TO : All Bidders
FROM : Bob Lavey
PROJECT : Nogales High School Interim Locker and Restroom Portables
Project 230384.41
SUBJECT : Addendum 2
DSA : 04-123338 / File 33-13

ADDENDUM NO. 2

DRINKING FOUNTAIN - EXISTING CONDITIONS

DRAWING NUMBER: **E1.2**

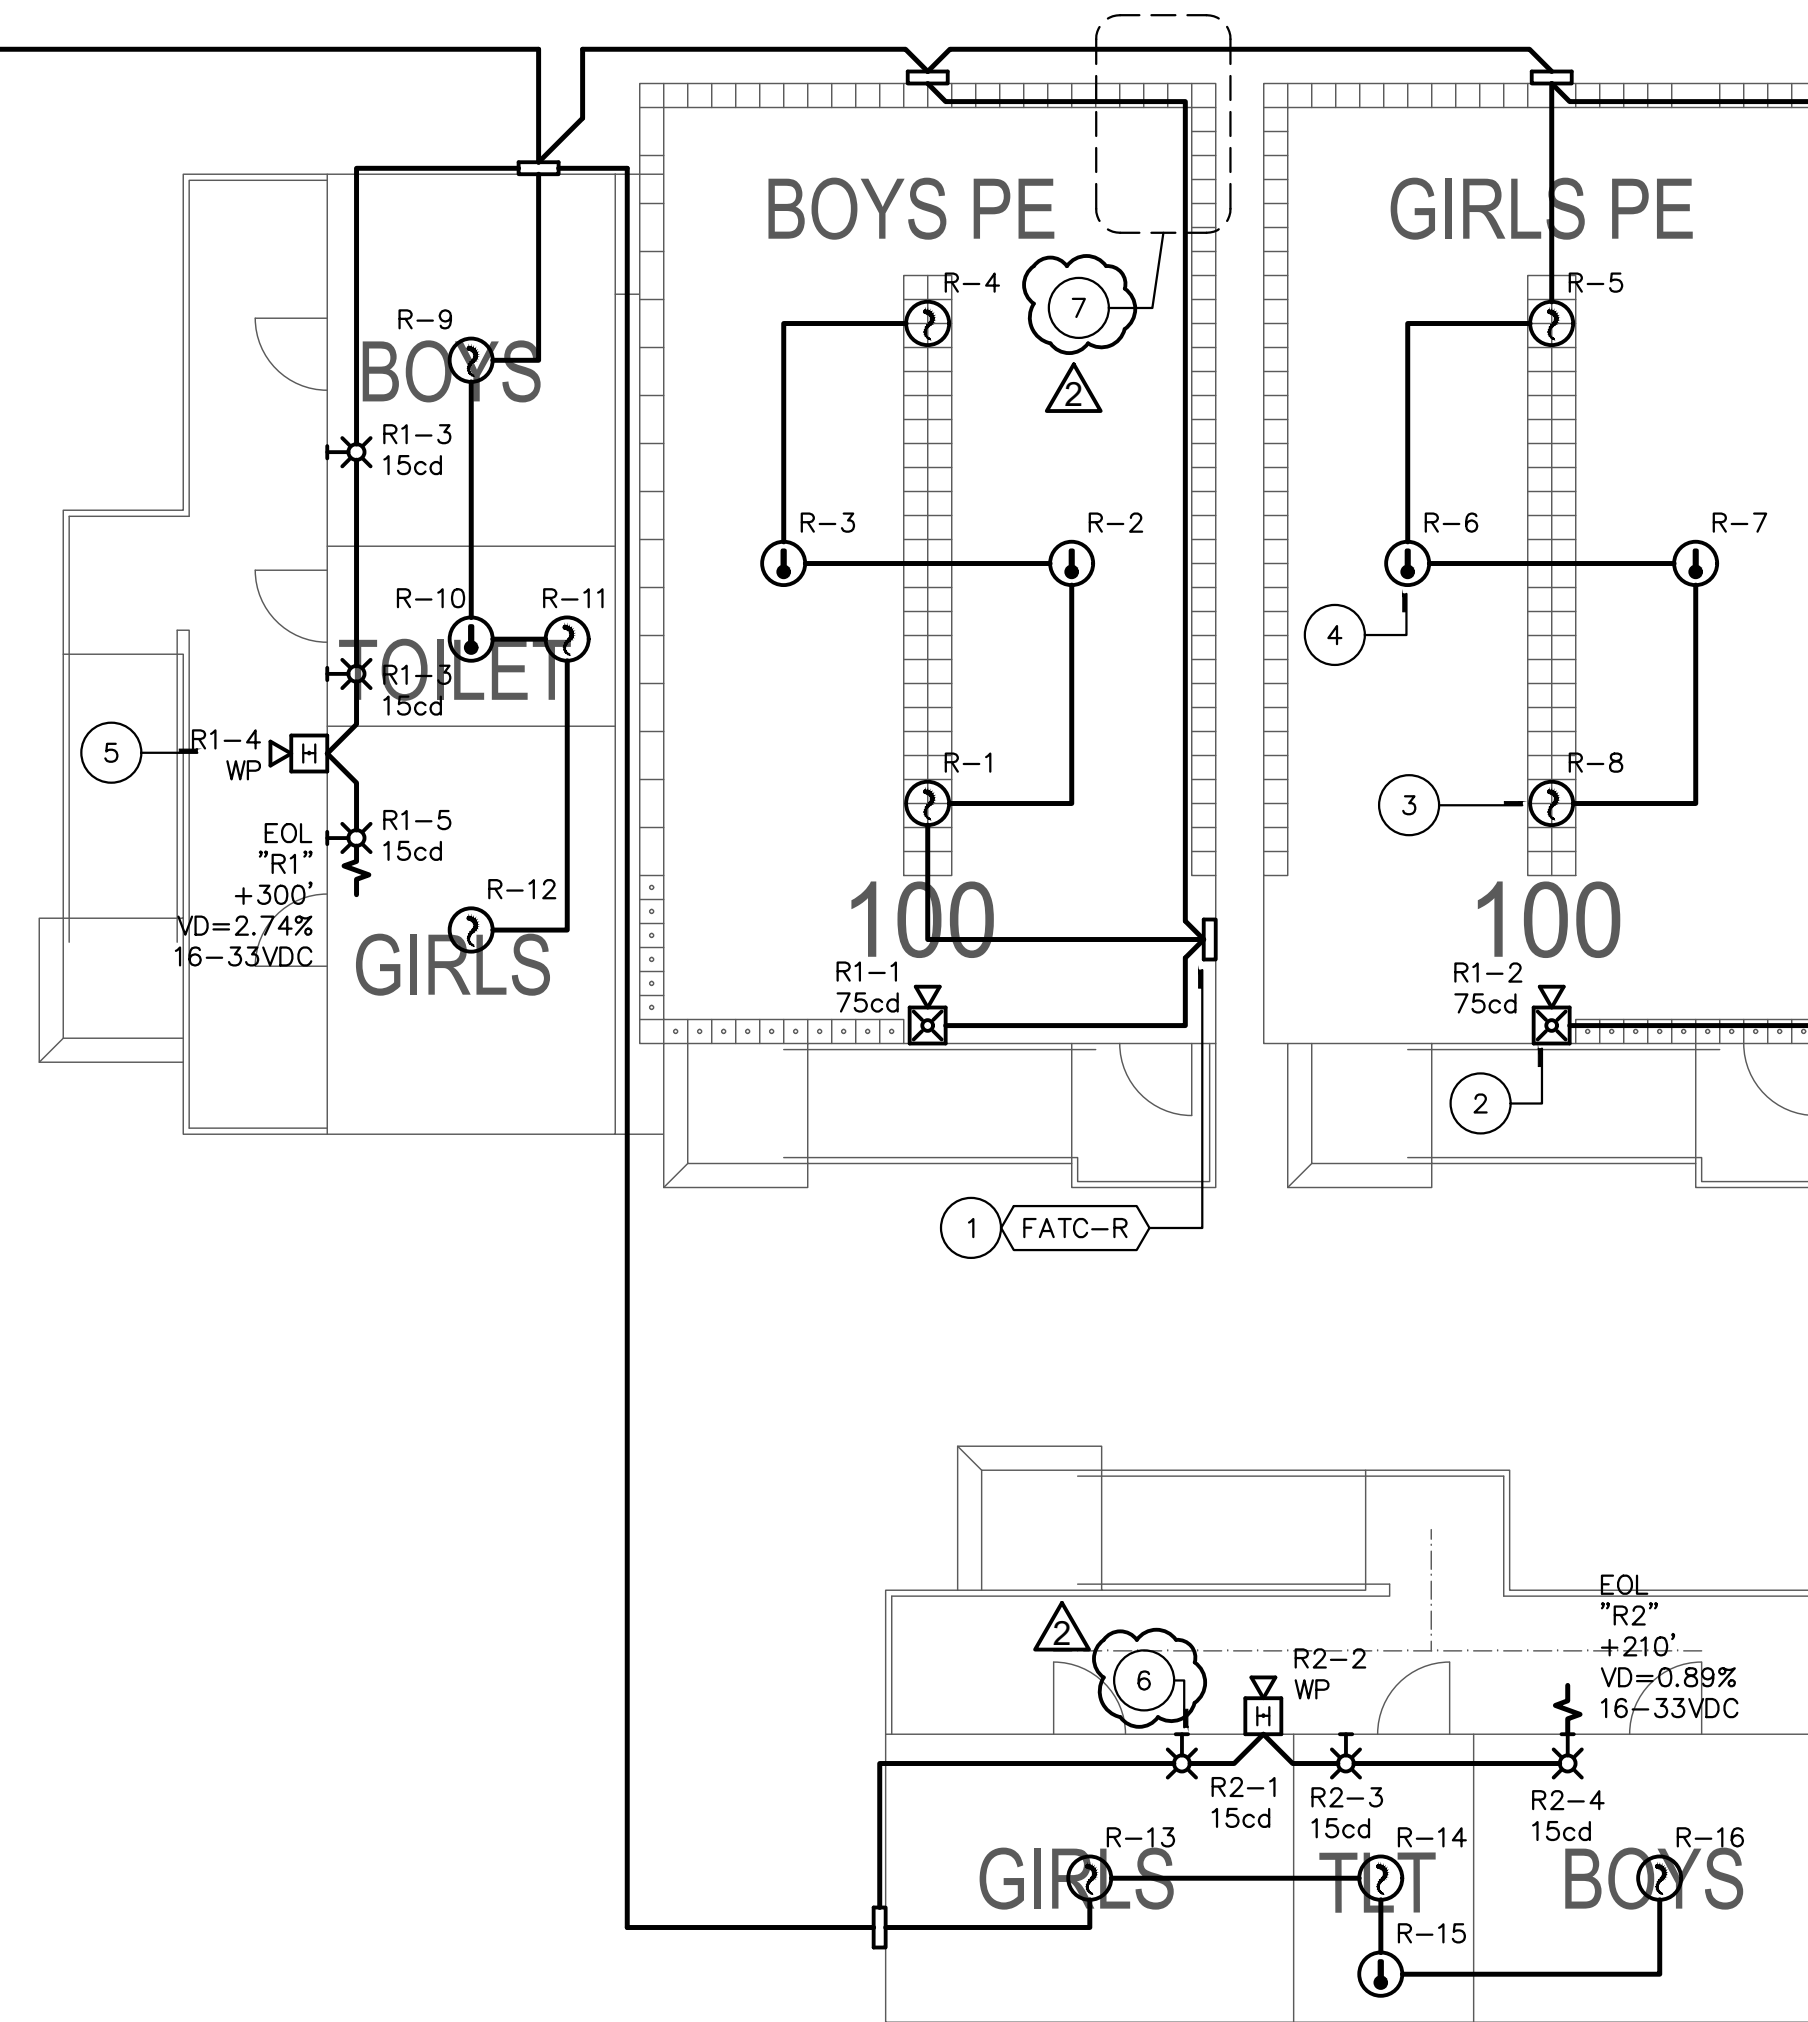
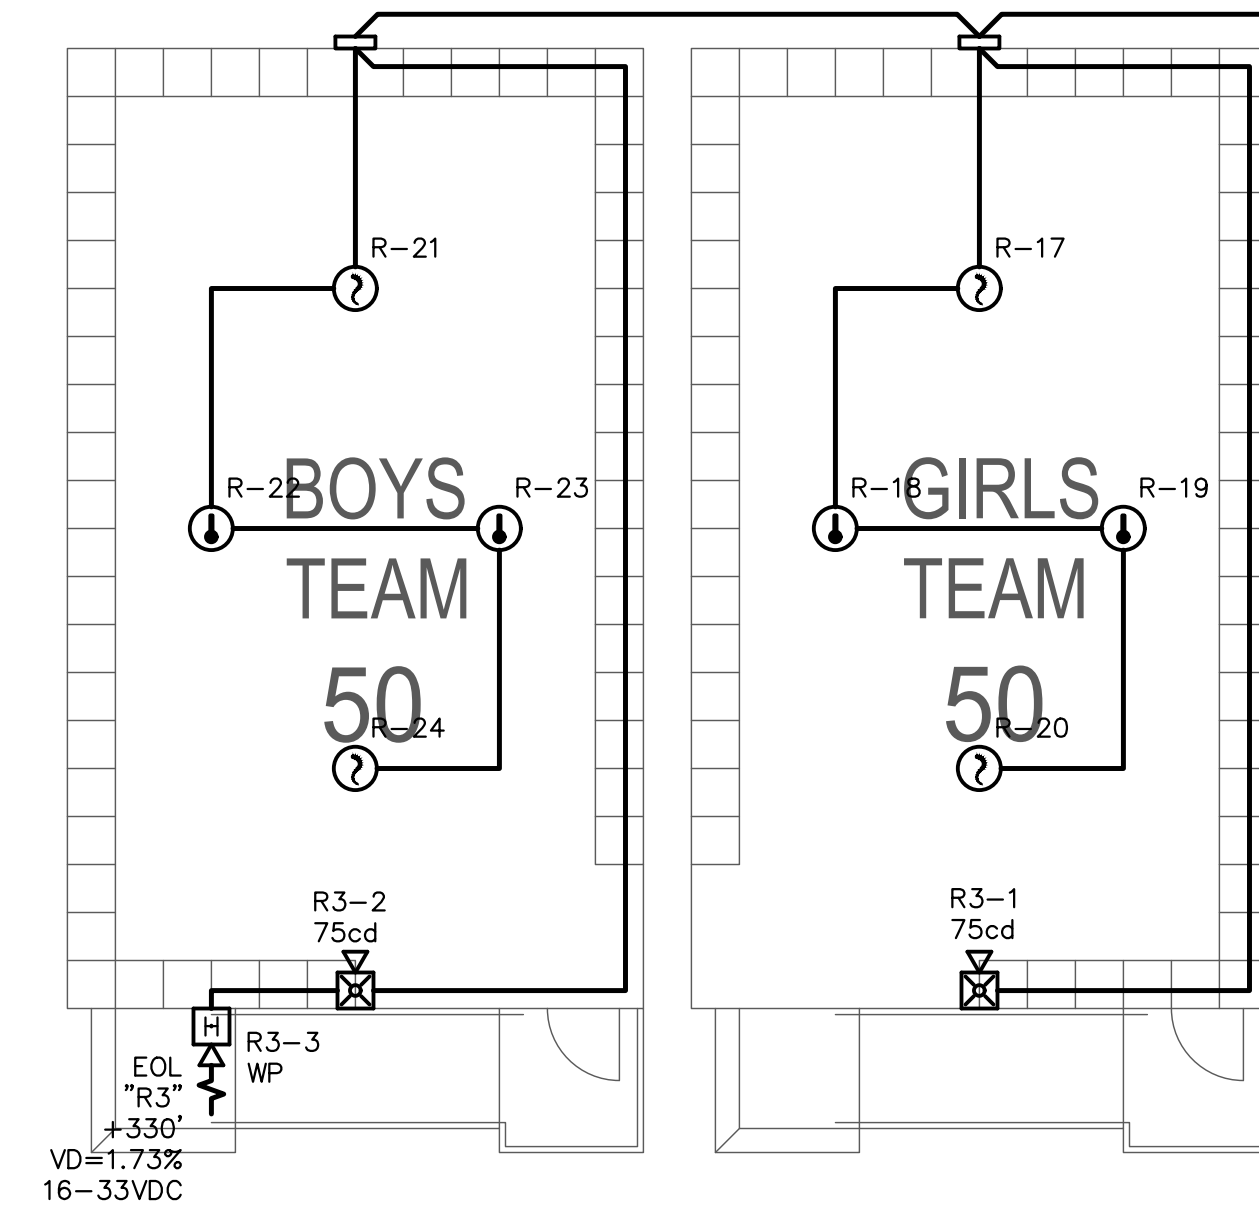
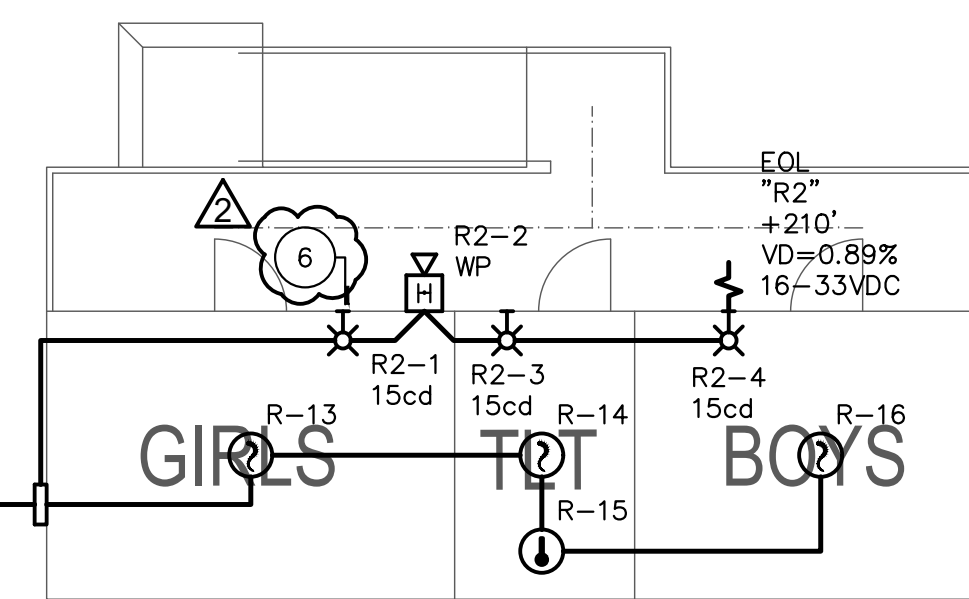
- A. Revised Reference Notes 4 and 8 along with General Note 3 per the attached Drawing E1.2.

DRAWING NUMBER: E2.1

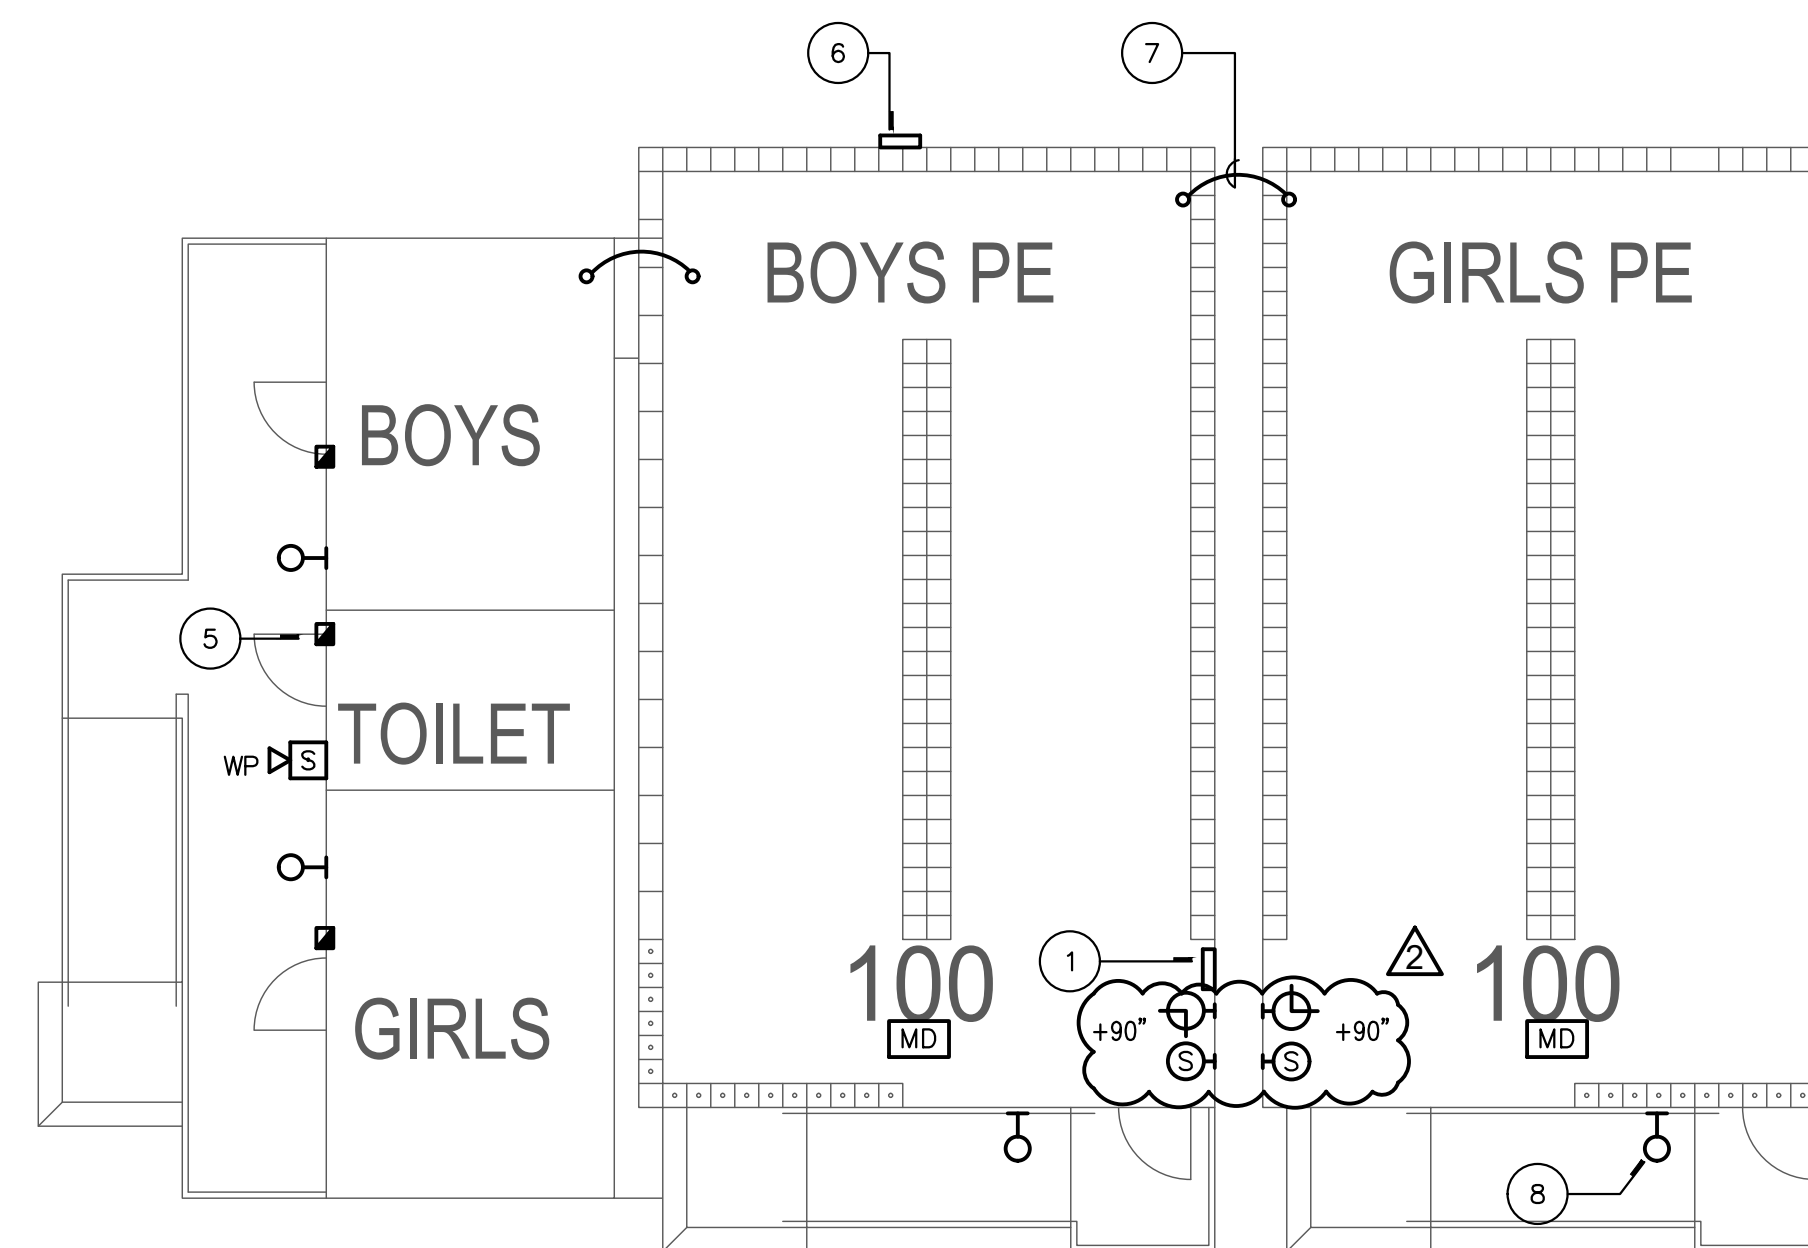
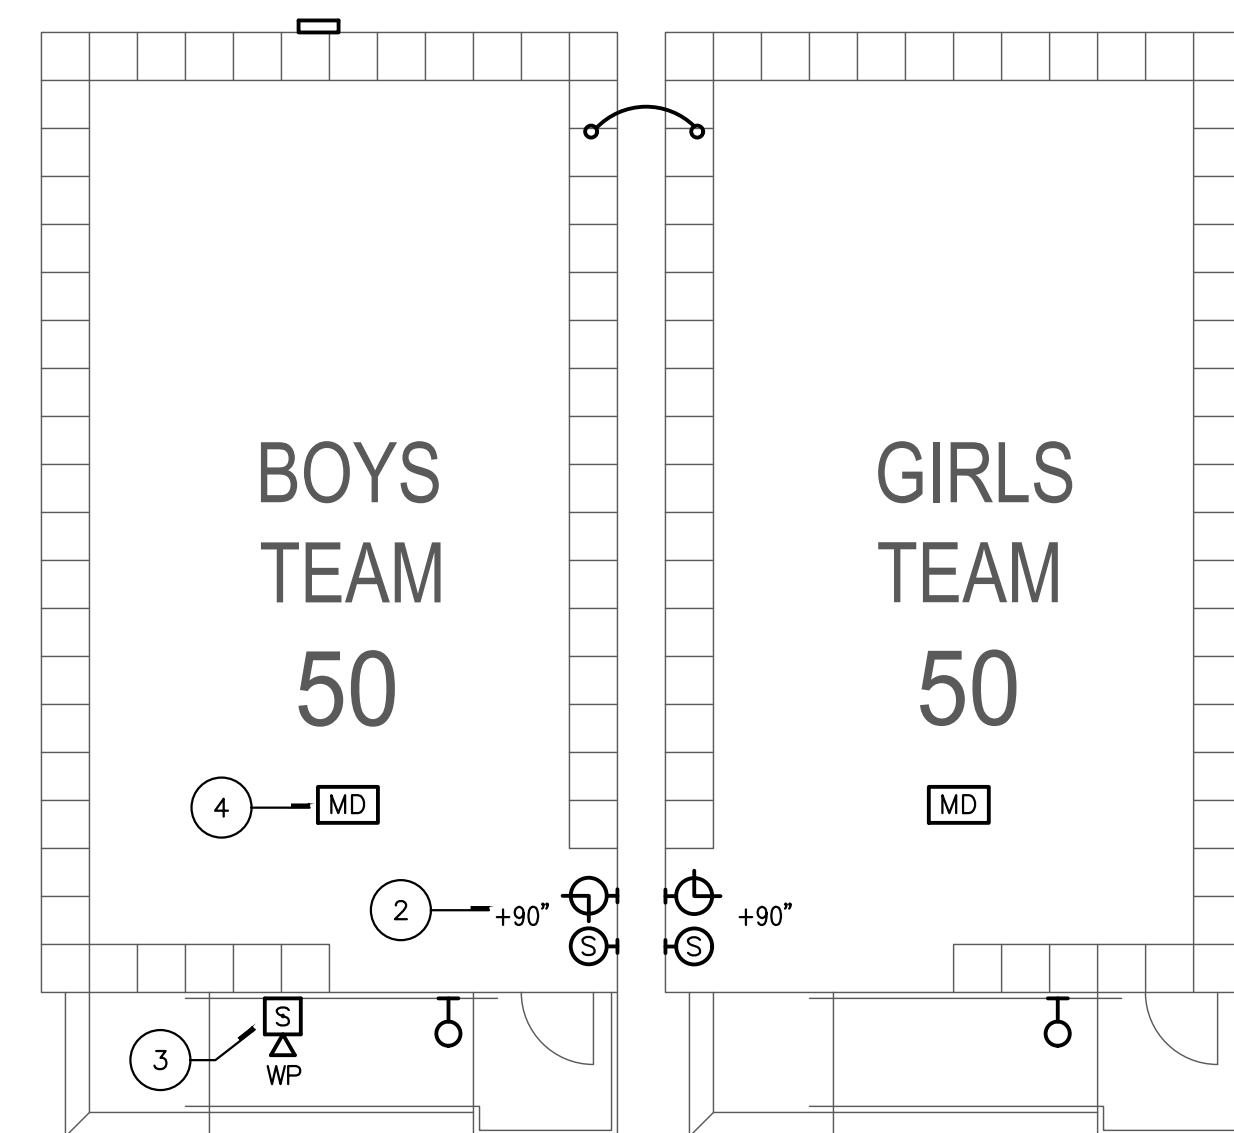
- A. Revised Reference Notes 2 through 7, revised General Notes and Signal Reference Notes per the attached Drawing E2.1.
